7
GFA/AD 220
SZD 23
24.11.1981
Issue 1
Sheet 1 of 2

AIRWORTHINESS DIRECTIVE

Modification to prevent the undercarriage retraction assist

spring becoming disconnected.

Fig.1.

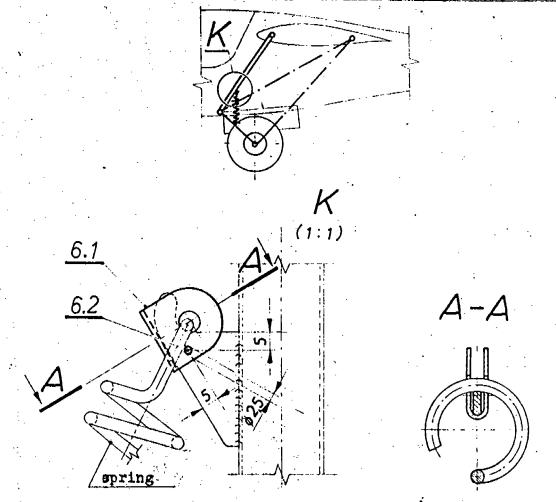
- (1) If a factory supplied lug is not available through the Australian distributor, a lug made to Fig. 1 from commercial mild steel sheet, approx. lmm thick, etch primed will be acceptable.
- (2) Remove seat pan & disconnect the spring from its top hook, with the undercarriage retracted.
- (3) Thread the lug onto the end of the spring.
- (4) Fit the spring & lug onto the hook, ref. Fig 2. and mark the small split pin hole from the lug onto the fixed hook. Remove the spring and lug.
- (5) Drill the split pin hole through the lug.
- (6) Assemble the spring & lug, back onto the hook, fitting a split pin, bending the legs.
- (7) Enter modification details into the glider's log book.

Ing. 6.1. /68-00-66/
material: 20-k /1x20x44/
protective cost - zinc plate
